BIG SCRUBGRASS CREEK MINE DRAINAGE
POLLUTION ABATEMENT PROJECT

SL-147

Errata Sheet

SITE 15

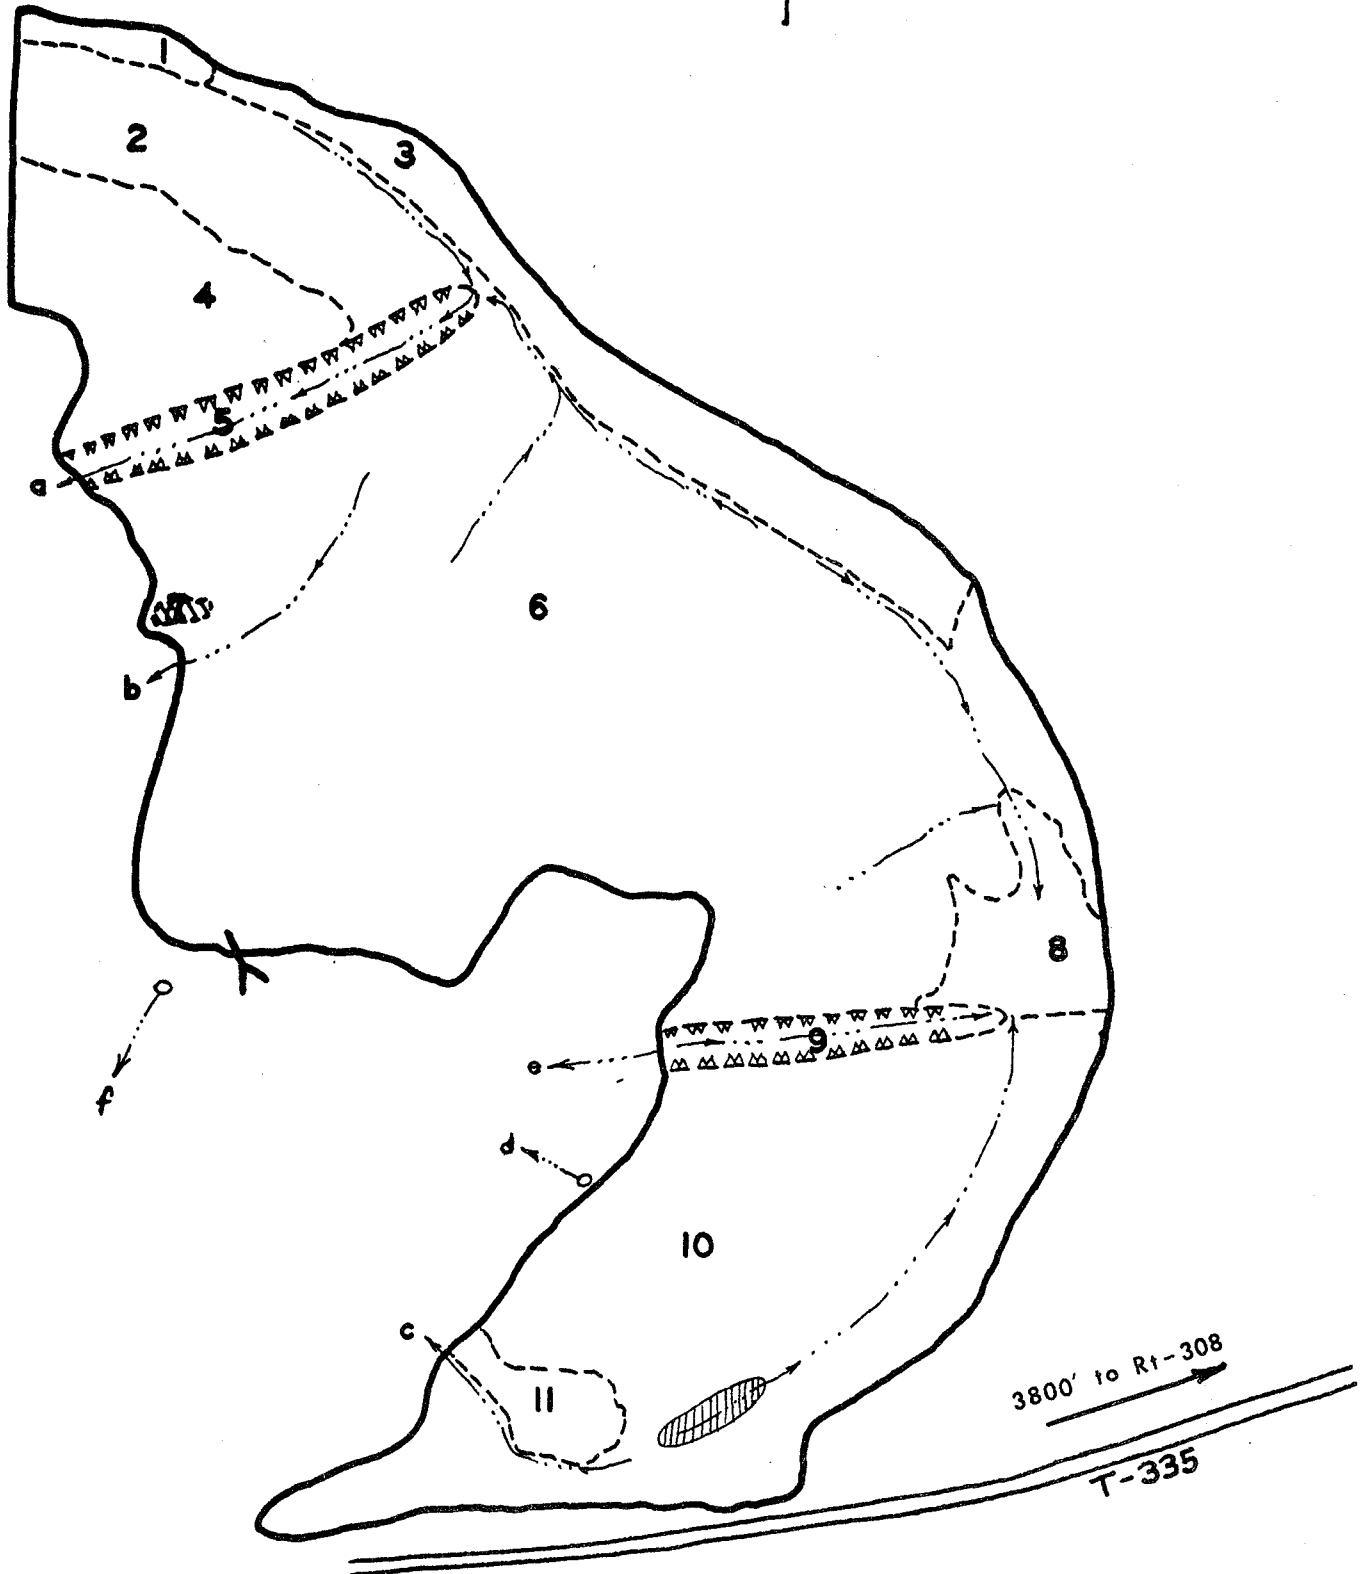
Page 233. Map opposite this page for Mine Site 21 shows a seepage point "d" outside the mine area. The quantity of water flowing from this point was not large enough to justify any reclamation work.
